**EAGLE MOUNTAIN CITY
CITY COUNCIL MEETING
JANUARY 7, 2014**

TITLE:	Gateway Phase A Plat 1 Final Plat		
FISCAL IMPACT:	None		
APPLICANT:	Sage Communities (Scott Kirkland)		
GENERAL PLAN DESIGNATION Mixed Use Residential	CURRENT ZONE Lower Hidden Valley – Residential Multi-Family & SFA - Townhomes	ACREAGE 7.21 Acres	COMMUNITY Lower Hidden Valley / The Ranches

EAGLE MOUNTAIN CITY
Planning Commission Staff Report

Project: **Gateway Phase A Plat 1 – Final Plat**
Applicant: Sage Communities (Scott Kirkland)
Request: Recommendation to City Council
Type of Action: Action Item

PLAT "A"

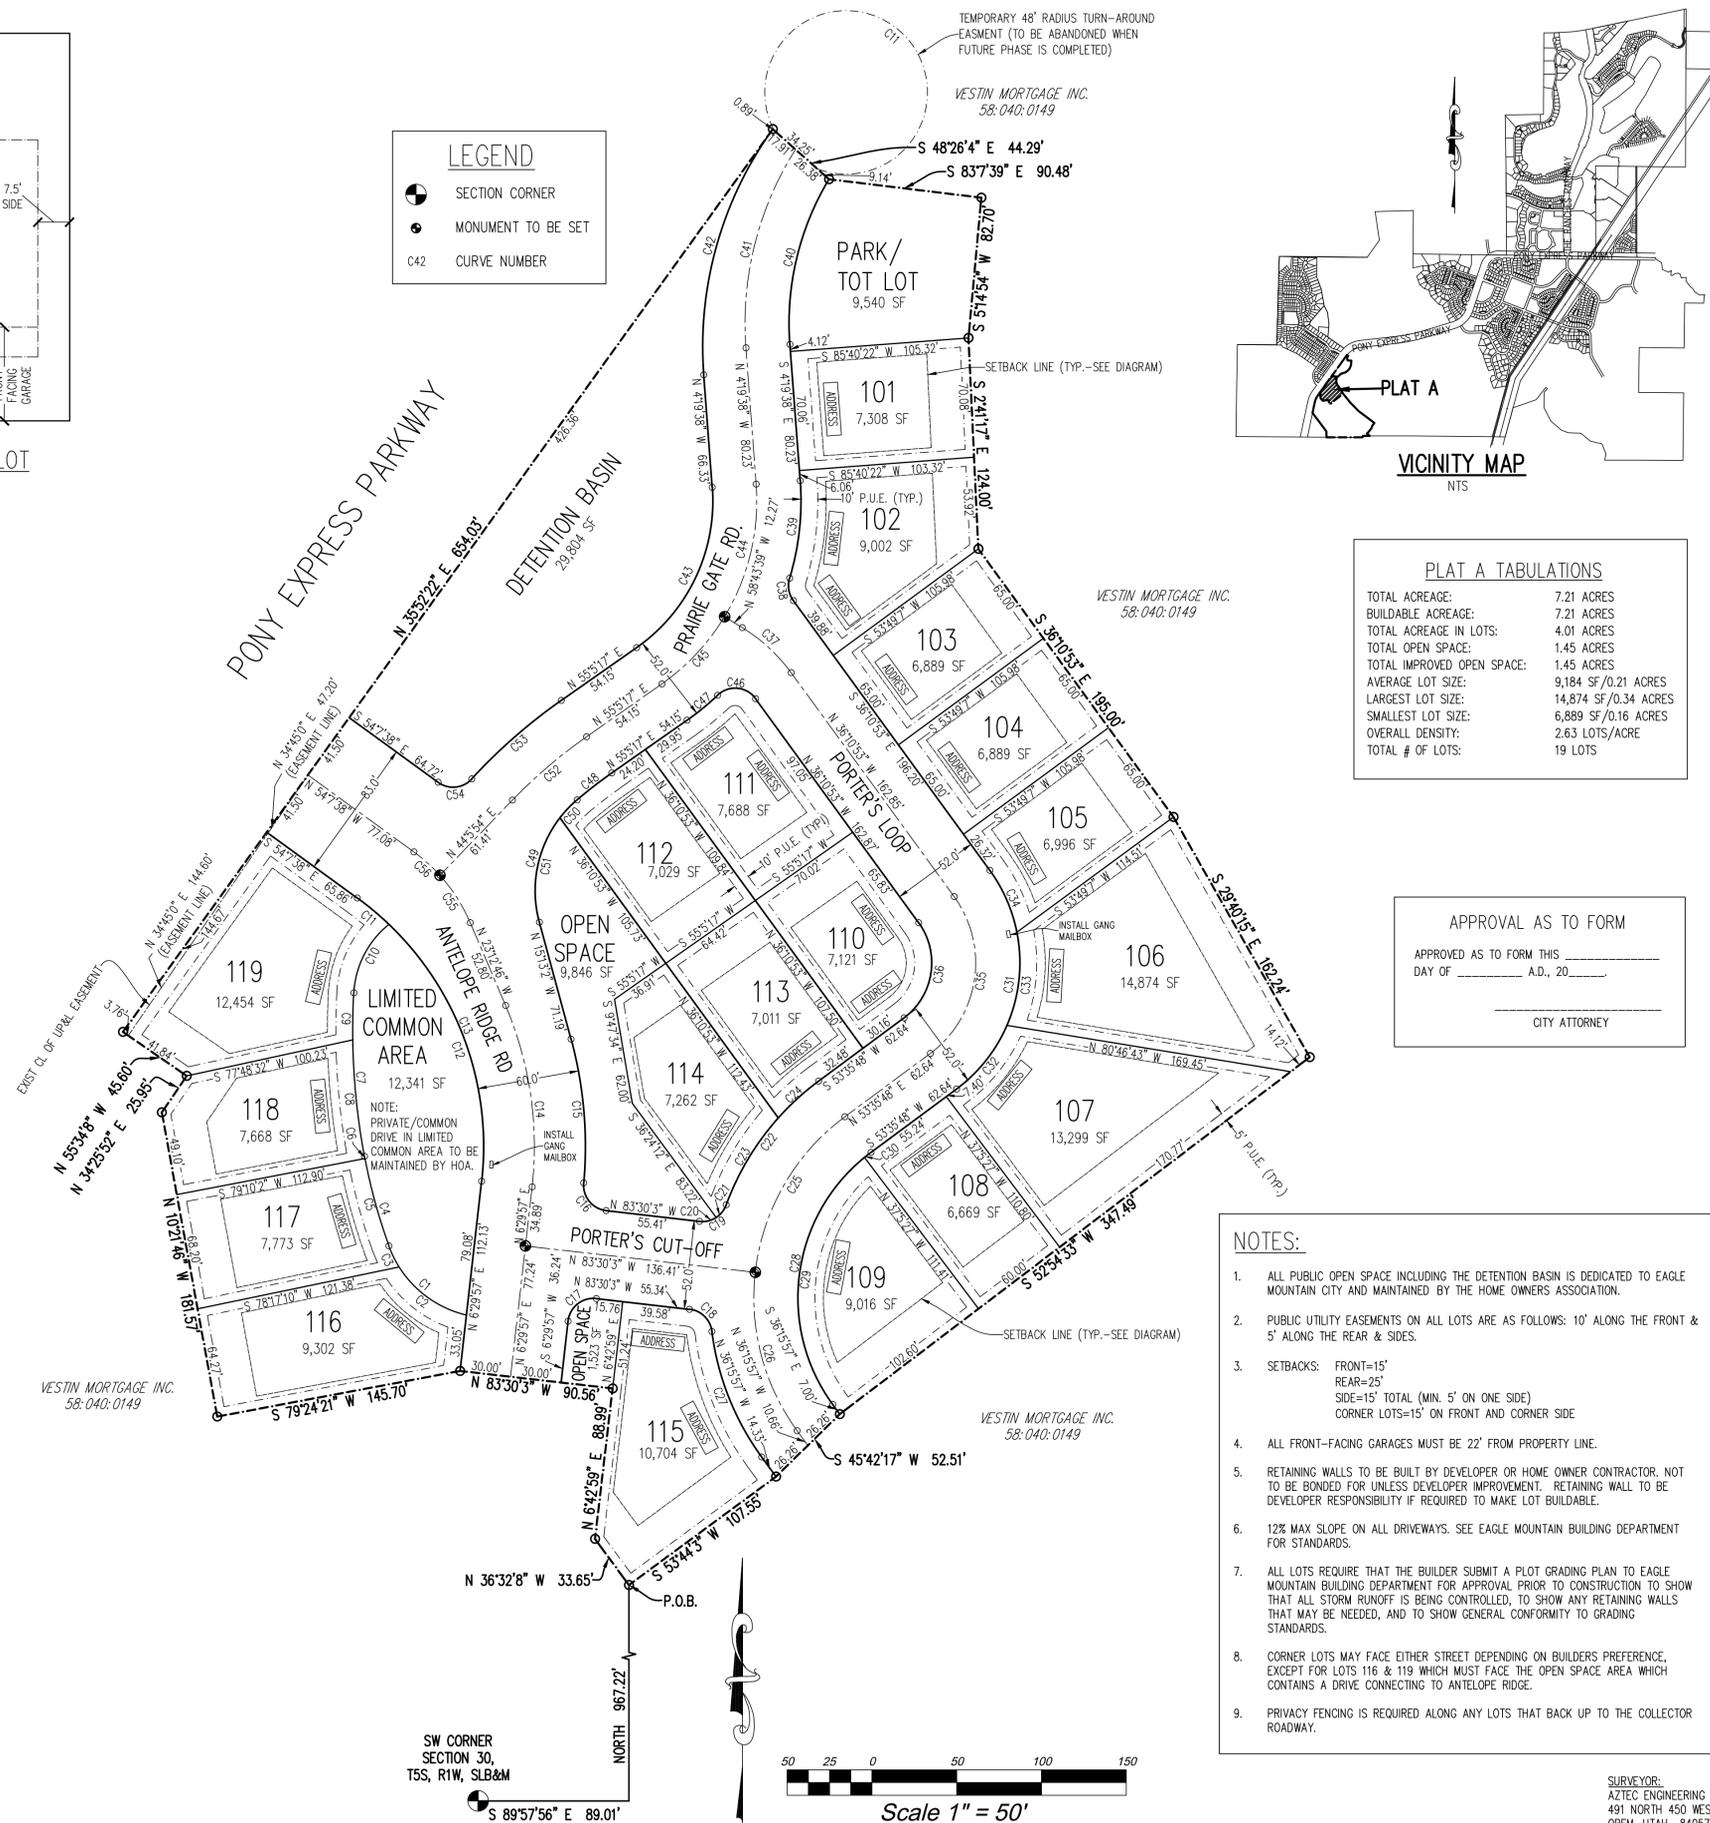
2. Propose a plan for petroglyph preservation prior to, or along with, the approval of the second final plat.
3. No parking on one side of the road near the trailhead pocket park.

4. Change street names so they do not reflect existing subdivisions in the city.
5. Changes to the natural gas regulator shed/building must be presented for approval to the Planning Department Staff prior to making changes to the shed/building. Access must be maintained to the building.

6. All streets are to be designed to meet all City standards for roads or alleys and must be approved by the Fire Marshal, and dedicated to the City.

2. Propose a plan for petroglyph preservation prior to, or along with, the approval of ~~the first~~ the second final plat.
3. No parking on one side of the road near the trailhead pocket park. *This can be accomplished with notes in the construction drawings.*

4. Change street names so they do not reflect existing subdivisions in the city. *The applicant will work with the staff to change names, if necessary.*

LP1.2

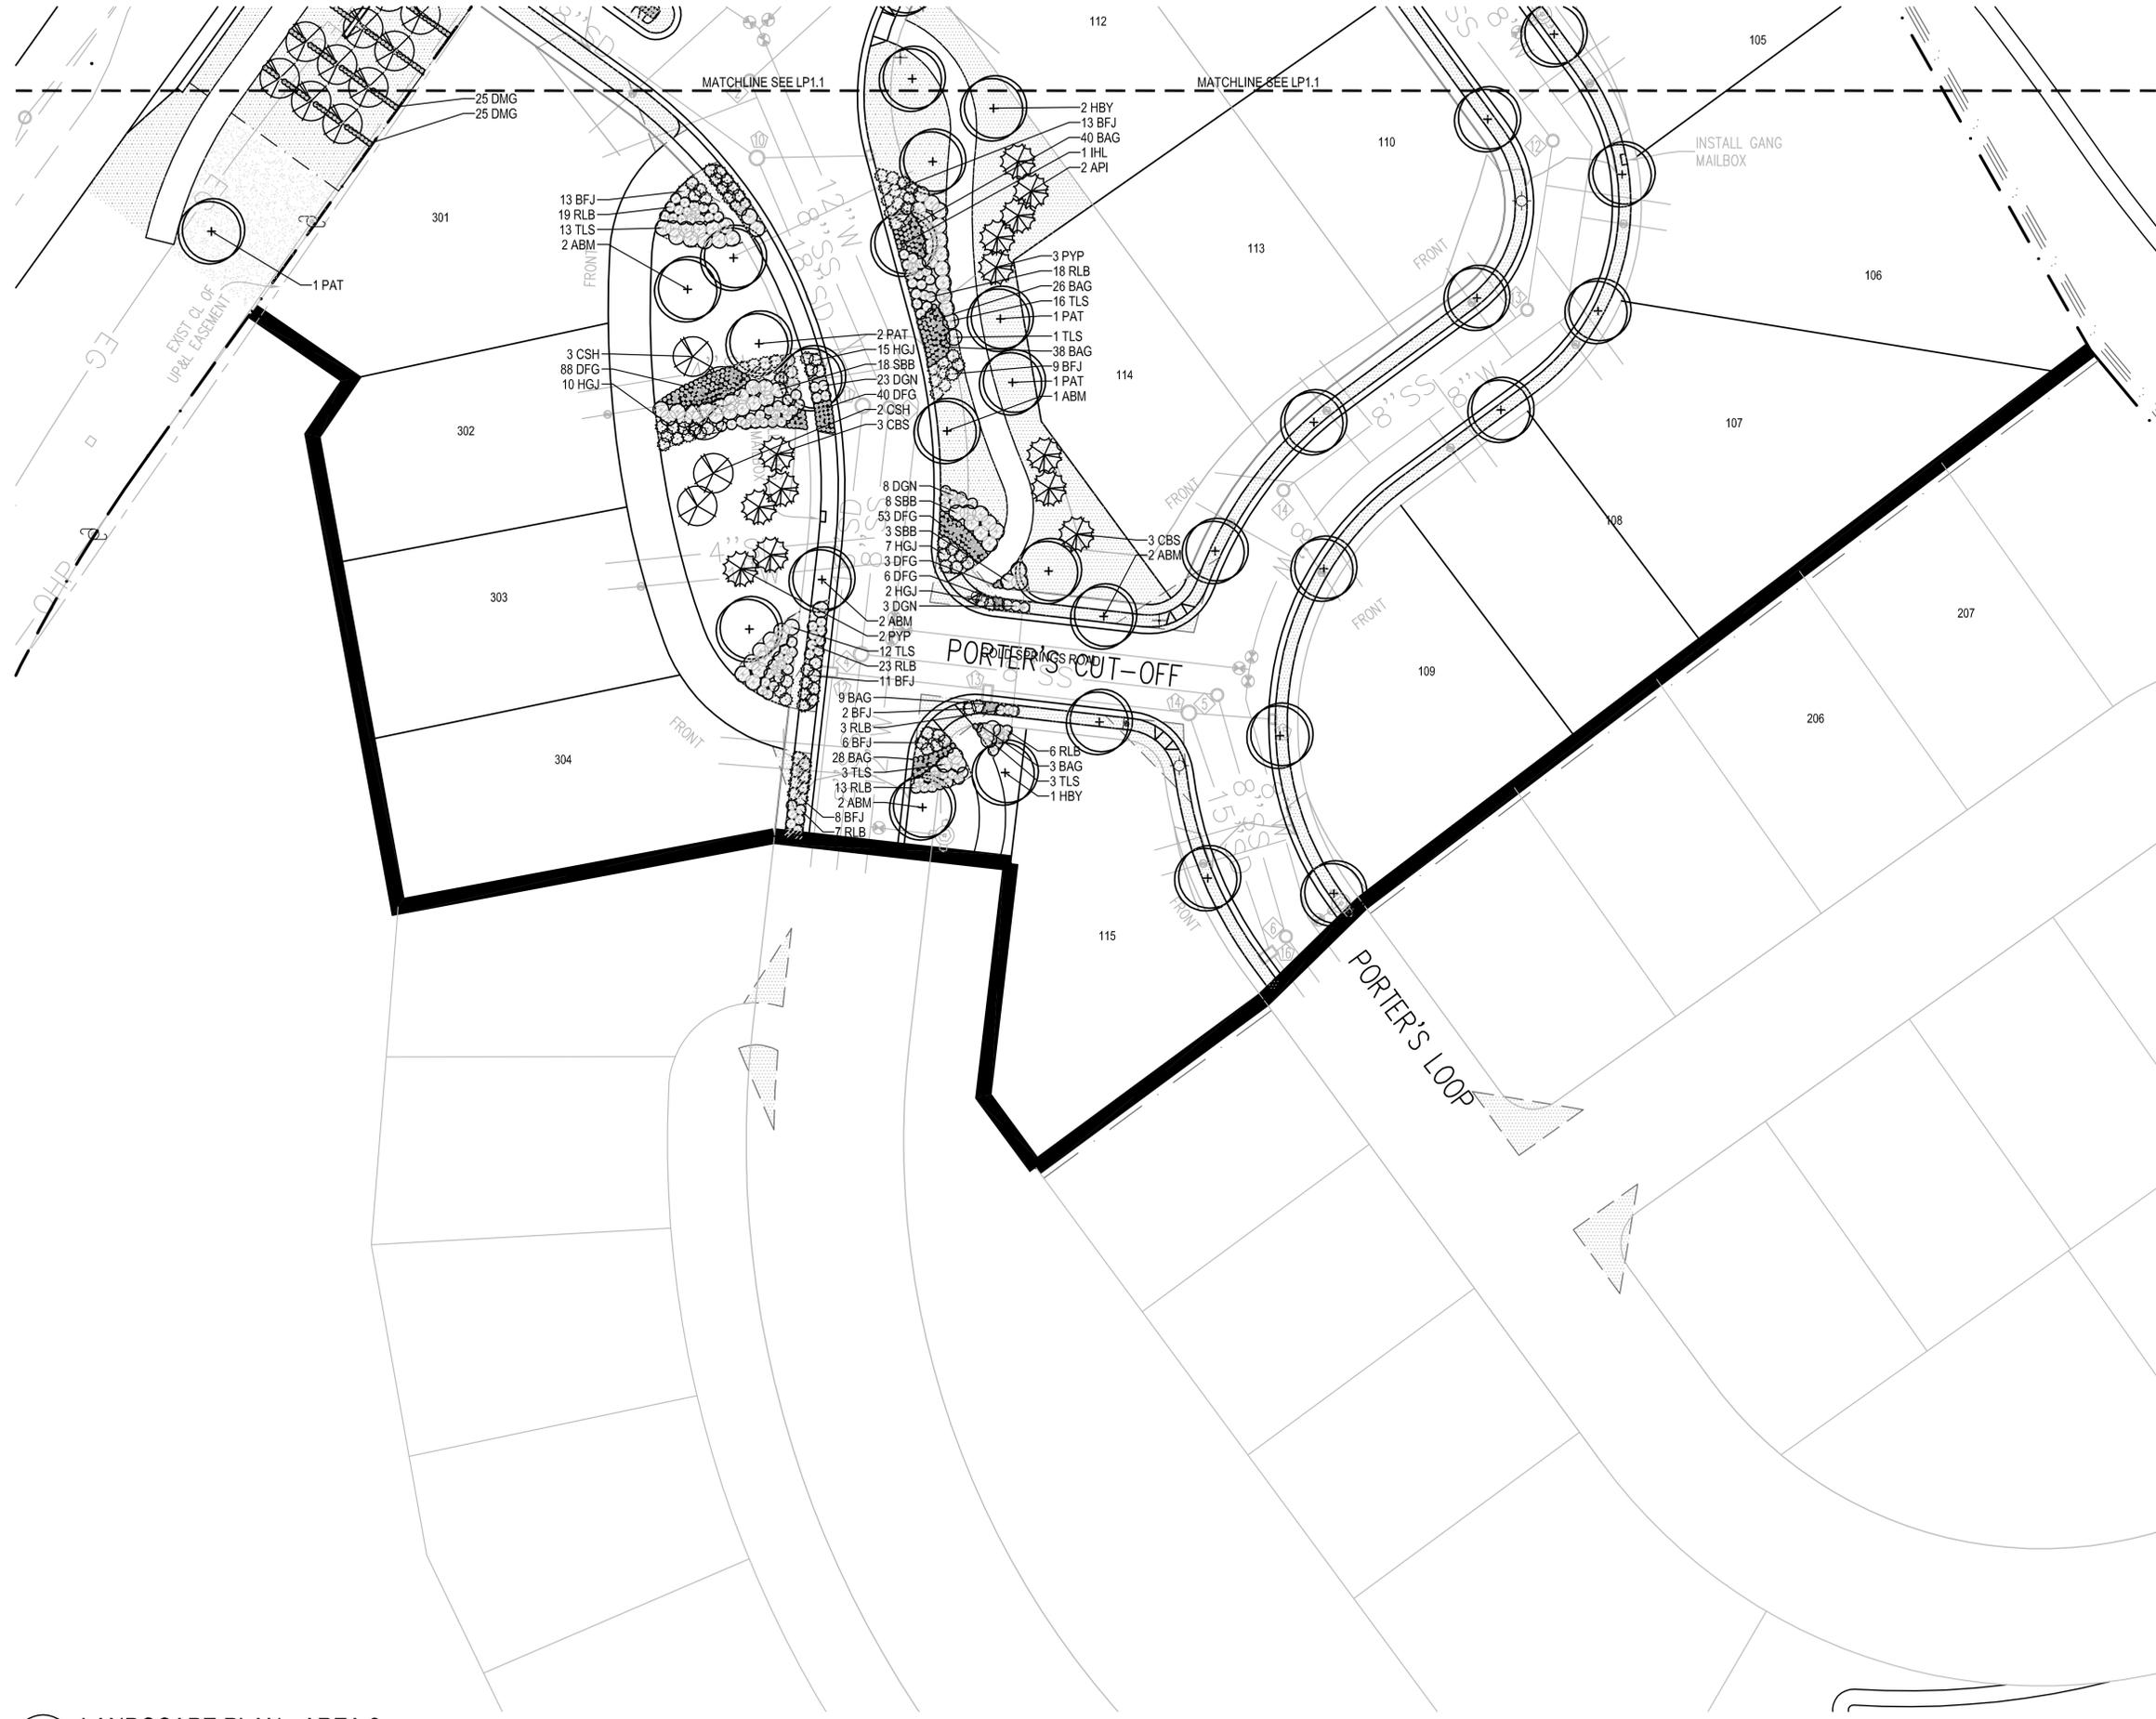
While the park space that has been provided is sufficient for this development, the landscaping plans still require some refining / additional information. For instance, we need to know what type of groundcover will be in the areas that were left blank & in the park – sod, seed, or natural seed. We need specifications on the pavilion and tot lot, and we will need irrigation plans submitted. These are

all items, however, that can be reviewed by the Planning Director and Parks Foreman for approval prior to beginning construction.
